# NSTX-U OH Fault Report on Extent of Condition

NSTX-U Arc Fault External Review  
May 28, 2015

Original implementation of OH water connections

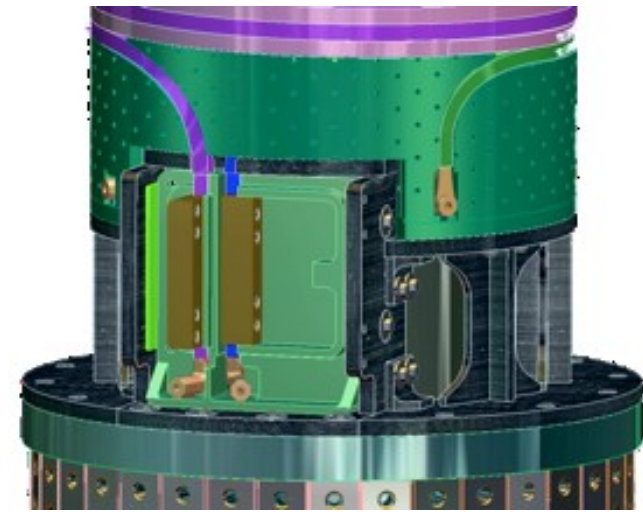
- Need an approved design with proper insulation - underway .
  - Original parts were field fit.
  - New design must have electrical engineering input to insure proper high voltage insulating techniques - underway.

OH lead blocks

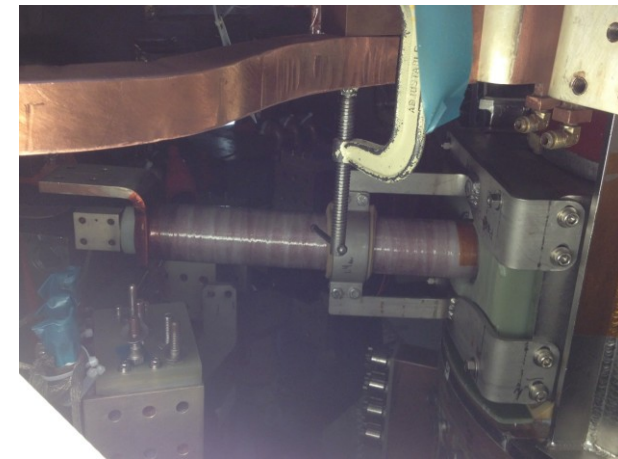
- Must insure integrity of joints – measure voltage drops for test current.
  - Use temperature stickers.
  - Check periodically
    - How can they be viewed?
  - Inner joints from coax connector to coil are insulated on side – measurement via water feed should be possible.
  - View accessible stickers periodically with borescope.
- Evaluate design assumptions – particularly with regard to the need for support of the inner conductor – and determine whether the feed must be potted, or if a system of shims around the inner conductor, is feasible.
  - The coax feed should be potted unless there is justification for altering the present design and requirements.
  - Be sure the design, construction, installation and analysis of the connector box are also consistent.
- Review the “high voltage hygiene” in the connector box.
- Consider a means of detecting series joint arcs in connector box.

# TF Outer – Inner Electrical Connections

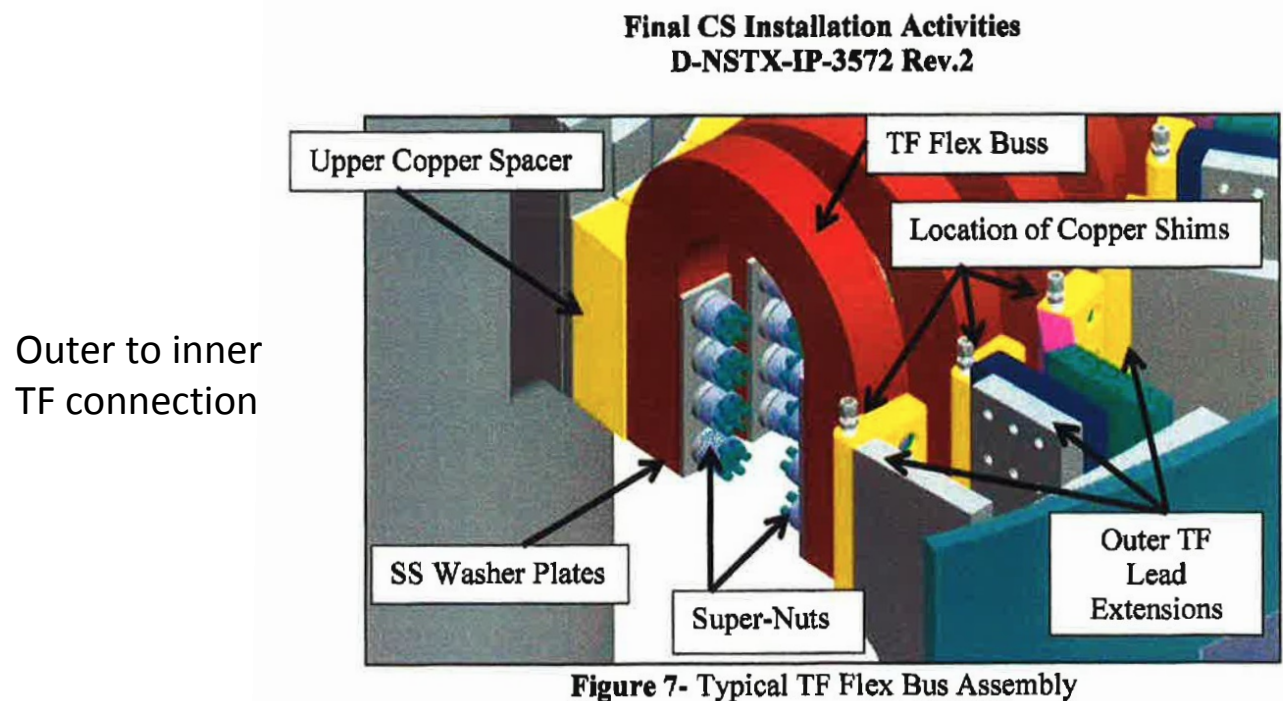
- Critical connection with several elements in series.
  - Fit-up is critical.
- Accurate joint resistance measurements are required.
  - NSTX-U has relied on purely mechanical measurements of joint characteristics. [torque, feeler gauges]
  - Investigate if techniques exist for proper measurement of joint resistance. Voltage across the TF inner leg connection can be measured via the water connection with current running through the connector assembly and the leg

Tarnish on silver plated connectors

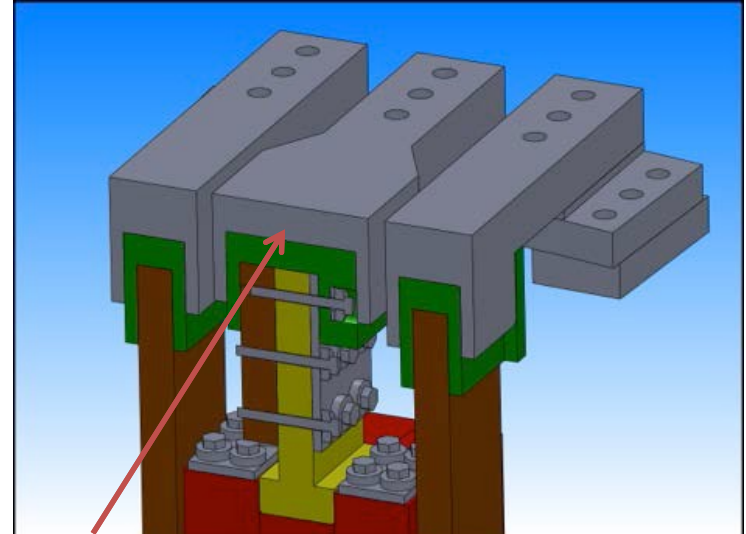
- Improve quality and uniformity of silver plating of contact surfaces.
  - Tarnishing of some of the silver plated areas has been observed.
  - Variable thickness, observable by eye, of silver plating?
- Cracking of G-10 spacers observed on some of the TF connector restraints
  - Structural adhesive will now be used to fill joints to prevent gaps causing stress. Tests for using adhesive with teflon mold release have been successful.
  - Any analysis on the expected performance of the adhesive?
- Use temperature stickers, monitor with a borescope or camera/fiber optic bundle.

G-10 caps that cracked → improve contact with structural adhesive??
